MEMO

RESPONSE TO THE PEER REVIEW OF THE ACOUSTIC ASSESSMENT FOR THE PROPOSED HIGHLAND LINE PIT LANARK HIGHLAND TOWNSHIP, ONTARIO

Please find below our response to the Peer Review by Jade Acoustics, dated 14 April 2025 of the “Acoustic Assessment for the Proposed Highland Line Pit, Lanark Highland Township, Ontario”, dated 23 September 2022, prepared by Freefield Ltd. (Freefield) on behalf of Thomas Cavanagh Construction Limited.

- 14.3 Figure 1: Showing proposed haul route and Analysis of Alternative Routes (Source: MHBC)

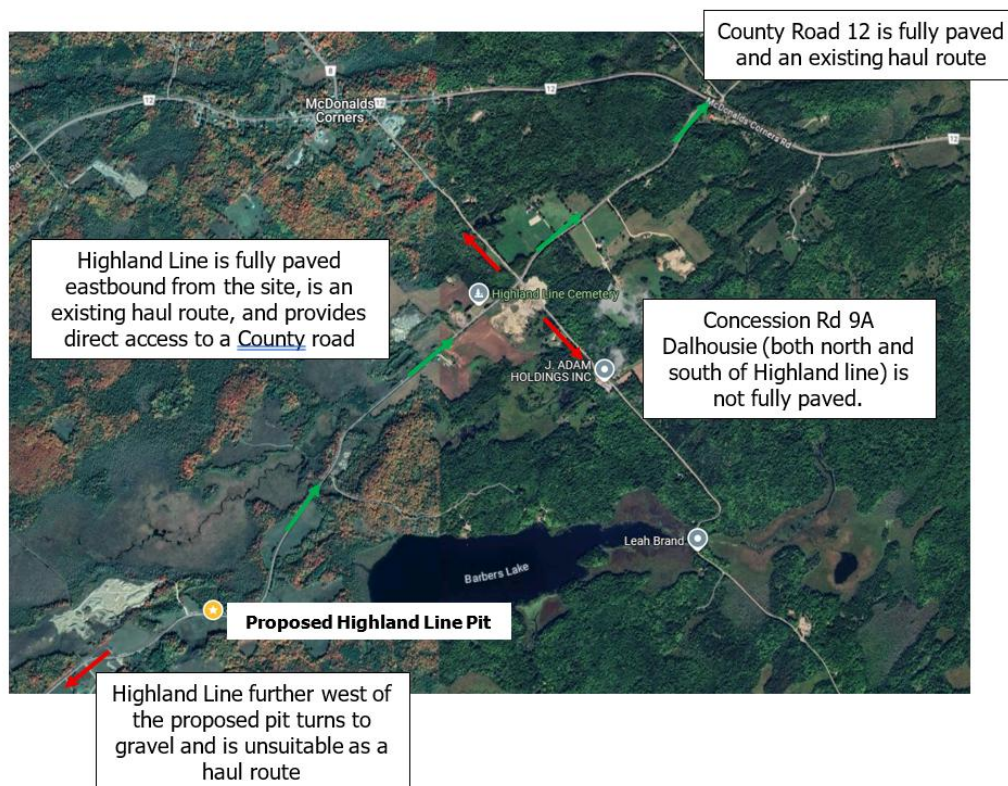
14. As discussed with the municipality, for completeness, an analysis of the off-site haul routes should also be included in the updated noise report.

- 14.1 An analysis of the off-site haul routes is typically carried out for new sites not on an existing haul route in order to analyse alternative routes to determine the haul route with least impact. The proposed Highland Line Pit is located on an existing haul route.

- 14.2 Irrespective of this, the proposed off-site truck traffic (off-site haul route) will travel east on Highland Line for approximately 2.7 km before connecting onto County Road 12. This is a significantly shorter haul route with far fewer residences, potentially impacted, compared to the alternative options. Given that the residential dwellings, in both east and westerly directions from the site, are at similar setbacks from Highland Line, the proposed haul route represents the haul route with the least impact. The proposed off-site Haul Route is shown on Figure 1 below.

- 14.4 To further address the public concerns related to truck traffic on Highland Line, the proposed hours of operations have been reduced to daytime hours only (07:00 – 19:00), and the maximum number of trucks (loads) leaving the site per hour has been reduced from thirty (30) to fifteen (15) per hour in total. Refer to Updated AAR, Section 2, pg. 6.
